20-COA-0141
121 + 123 S. 7th St.

West Main Architectural Review Committee
Public Hearing

Bradley Fister, Historic Preservation Specialist
Sept 09, 2020

Fire Escape Details

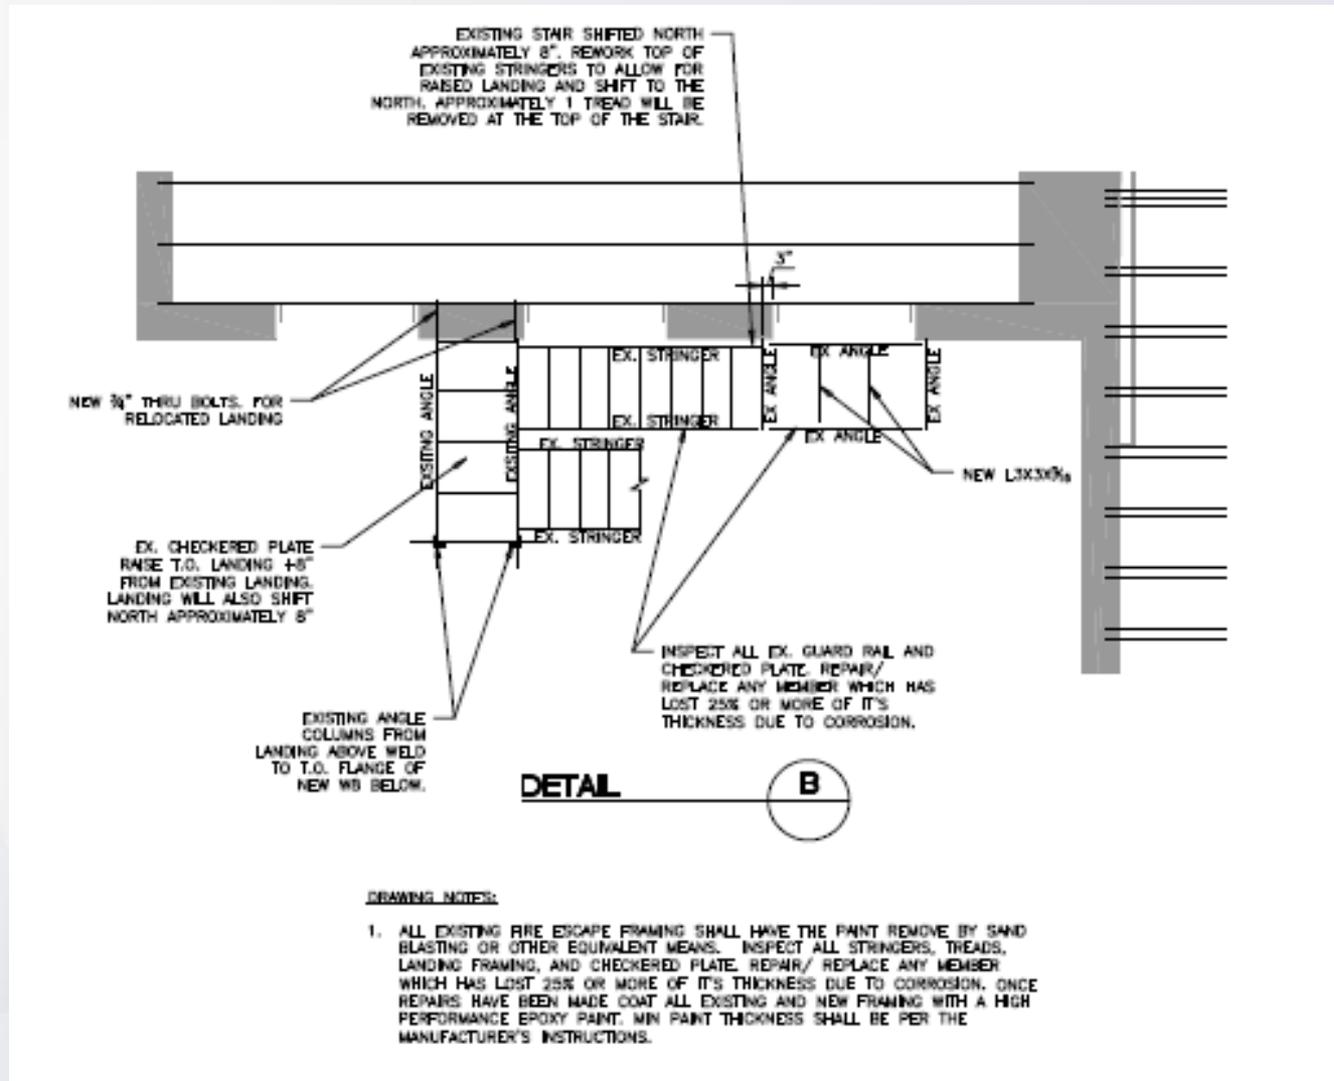
The applicant also proposes to reinforce the existing fire escape on the rear of the building, and to add a walkway to it on the second floor to connect to one of the windows as another form of egress. The escape will be cleaned and painted uniformly.

The proposed changes to the fire escape, including the addition of a walkway that will connect to a window for egress purposes, meet the **Addition** Design Guidelines for the West Main Preservation District especially **A15**.

- 2. All new windows shall fit the historic window openings. The glass shall not be smoked, tinted, low-E, or reflective. Clear low-E glass is permissible.**
- 3. If the modifications to the fire escape should impact the historic fabric of the building in anyway the applicant shall contact staff prior for approval.**

Continuation of Case

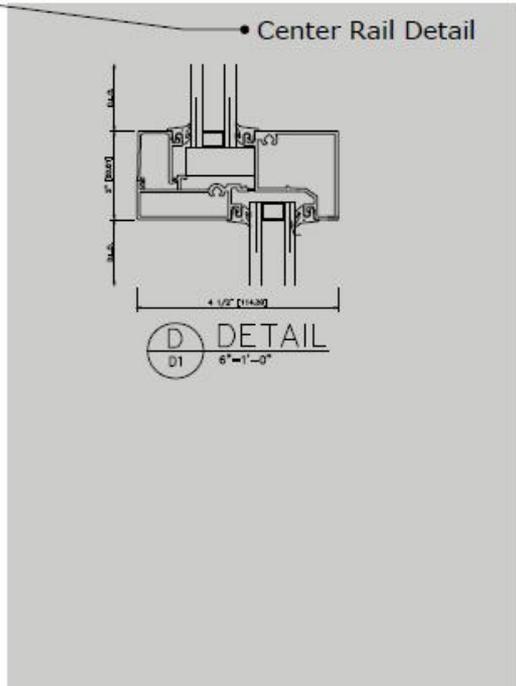
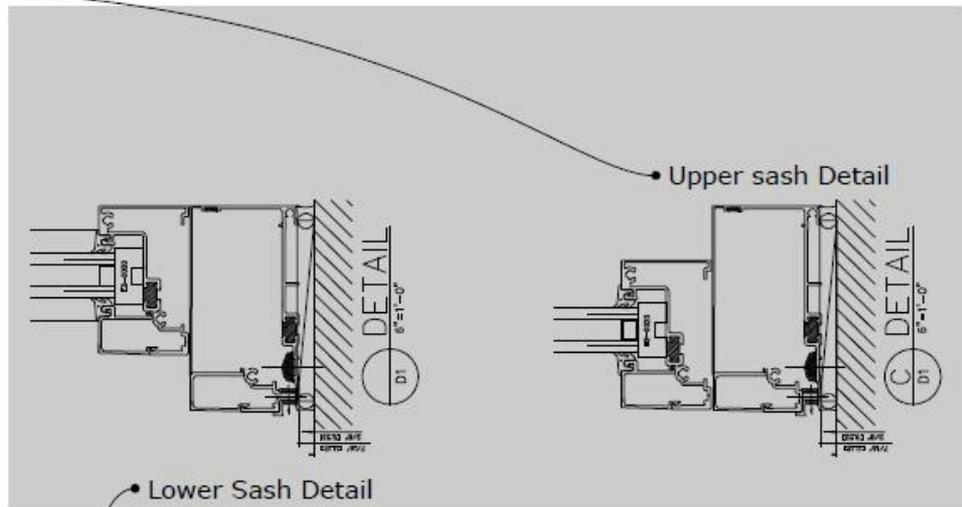
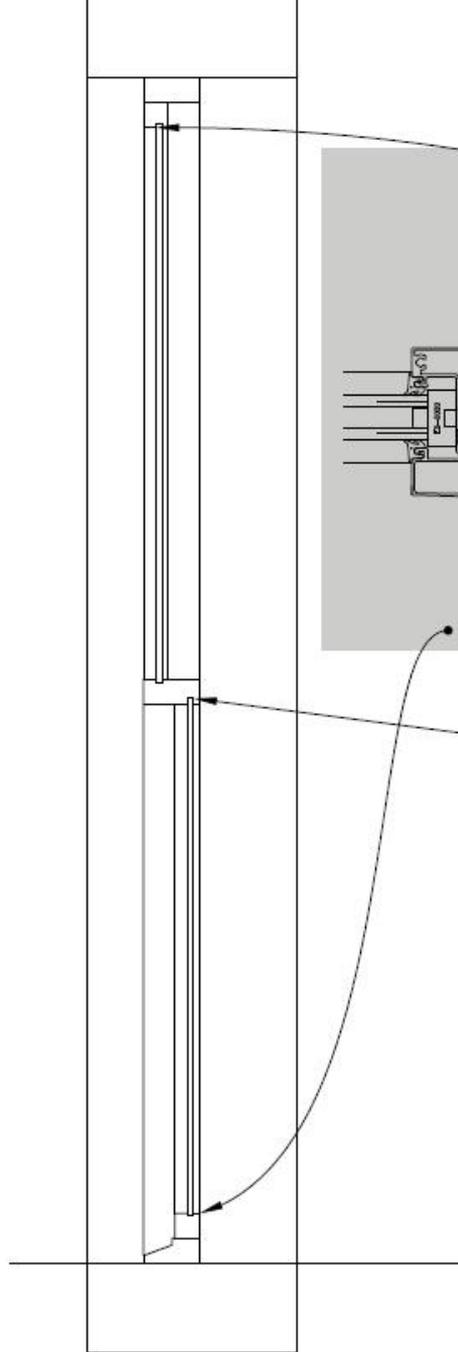
The applicant has researched the aluminum window frames available that could give the appearance of a double-hung window (as suggested by the committee), as well as design and cost associated with this, and does not wish to proceed with the suggested adjustment. Their main reason is that it would be a field alteration to the unit in order to accomplish this look, and there are concerns about the performance of the unit over time, as well as the structural integrity with respect to the size of the opening

The applicant would like for the committee to approve their originally proposed window design. The applicant has provided images from two other properties in the district that have similar windows as to what they have proposed.
